**United Kingdom Holocaust Memorial  
and Learning Centre**

Environmental Statement Addendum (Volume 2)  
Main Text  
April 2019

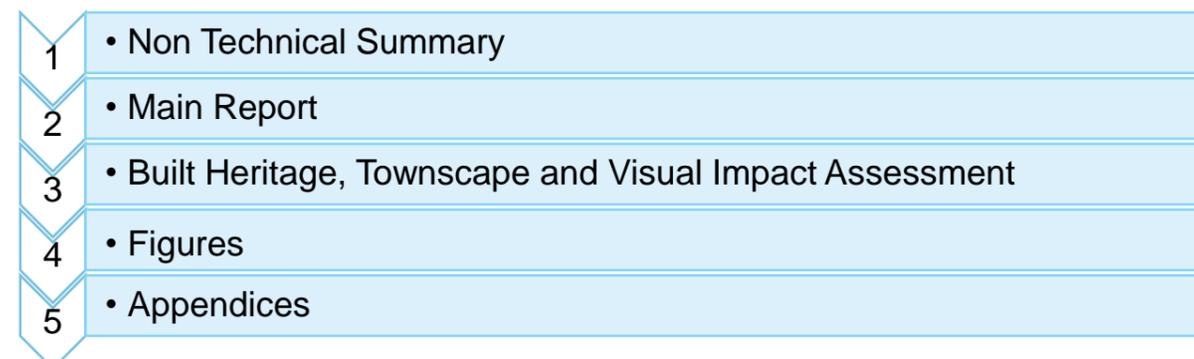
- 1.3.1. The amendments to the Scheme are summarised as follows:
- Reduction in the overall perimeter of the proposed learning centre which includes change in shape of the northern and western walls.

- Reduction in the footprint area of the learning centre by 213 m<sup>2</sup> with this area being added to the mezzanine level. The building footprint of the learning centre will still retain the current 3,258 m<sup>2</sup> area.

- Reduction in materials required for excavation from approximately 30,000 m<sup>3</sup> to 27,320 m<sup>3</sup>.
  - Changes to the design of the entrance pavilion to create a lighter, more transparent element which enhances and complements the existing gardens. This includes changes in height (reduced by 1 m) and area.

- Redesign of the memorial courtyard to reflect the changes to the entrance pavilion.
  - Redesign and relocation of the skylight, approximately 13 m north.

- Internal developments to the exhibition space in the basement and mezzanine levels within the learning centre. These include extended mezzanine floor, stair and vertical lift access and ceiling and acoustic improvements.

3.1.2. The general layout of the Scheme has not been altered however, the Scheme Plan showing the December 2018 layout (Figure 3-1) has been updated to reflect the new design of the Entrance Pavilion (Figure 3.2).
